Customer Notification

IE-703239-G1-EM1™

In-Circuit-Emulator

Operating Precautions

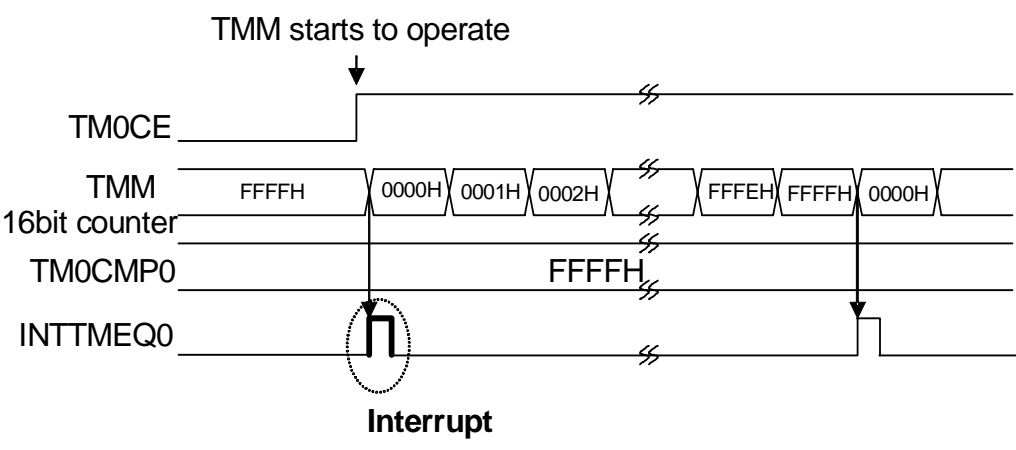
No. 11	TMP0 pin function (Technical limitation)															
<p><u>Details</u> The alternate function of port pin P32 has changed (V850ES/FJ2: pin27; V850ES/FG2: pin27; V850ES/FF2: pin24; V850ES/FE2: pin24). Before: P32/ASCKA0/TIP00/TOP00 After: P32/ASCKA0/TIP00/TOP00/TOP01 Therefore the setting of PMC3.PMC32 has changed accordingly. Also the assignment for PFC3 and PFCE3L have changed:</p>

<p><u>Workaround</u> There is no workaround.</p>		PFCE32	PFC32	P32 pin control mode specification	0	0	ASCKA0 input	0	1	TOP01 output	1	0	TIP00 input	1	1	TOP00 output
PFCE32	PFC32	P32 pin control mode specification														
0	0	ASCKA0 input														
0	1	TOP01 output														
1	0	TIP00 input														
1	1	TOP00 output

Figure 1: Behavior at pending TRQ

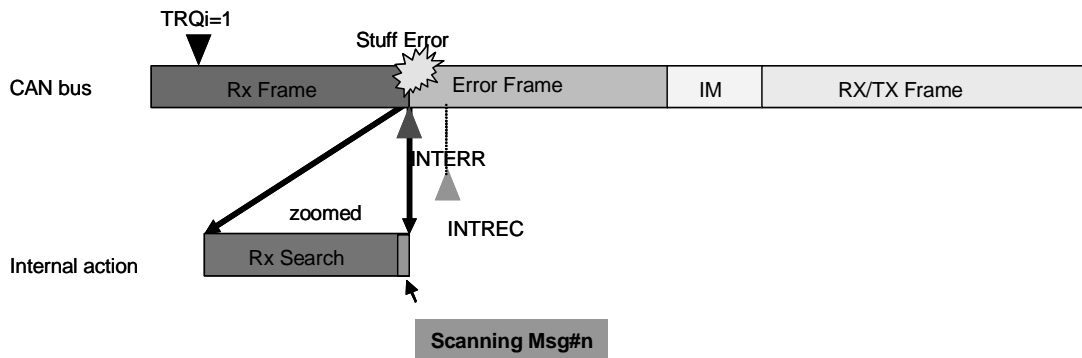
When the host processor has already submitted a transmit request (TRQ) for at least one buffer, the unexpected reception of the message will take place into the message buffer found by internal RX-search. This is the correct location to store the message i.e. the acceptance filter criteria are correctly fulfilled. However the data part will be updated with the contents of the shift register of the CAN protocol core. As this register is immediately stopped at detection of the bus error, the data provided to the message buffer can not be interpreted by the host processor.

No. 28	aFCAN: Rx limitation (Technical limitation)
	<p><u>Workaround</u></p> <p>NEC will update the affected products. NEC does not recommend a S/W workaround as first choice as it is fairly complex. On the one hand it is based on the control of submitting transmission requests only when the bus is idle. On the other hand a less complex algorithm can be used which does not prevent the unexpected reception but detects it safely and discards the unexpected reception in the CAN S/W driver. Any of these algorithms require that message buffer #0 is not used or that a 'dummy' TRQ in an unused buffer is set. This prevents behaviors as described in 2.</p>

Figure 2: Behavior without pending TRQ

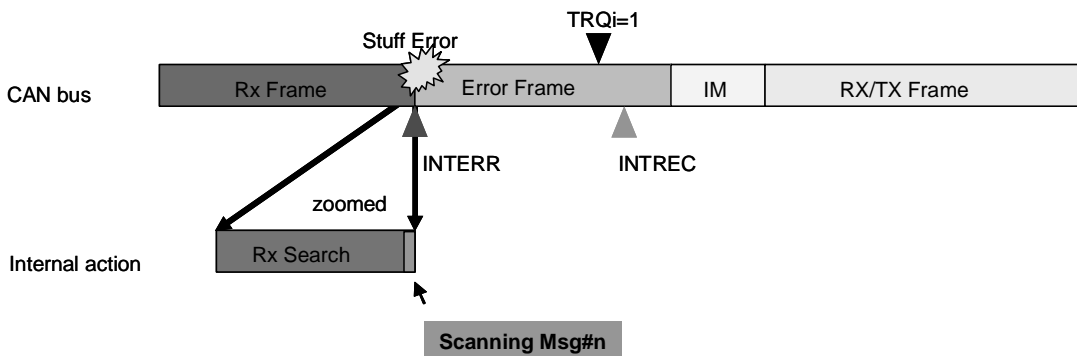
In case the host processor has not submitted a transmit request (TRQ) for any buffer before the detection of the bus error but submits TRQ = 1 after that point in time (see figure below) before the re-transmission of the message interrupted by the stuff bit error started, the unexpected reception of the message will take place.

The unexpected storage of the message is issued in the particular message buffer that matches the acceptance filter criteria at the time where the bus error is detected (as described in 1.) or the message buffer #0 is overwritten independently of its configuration.
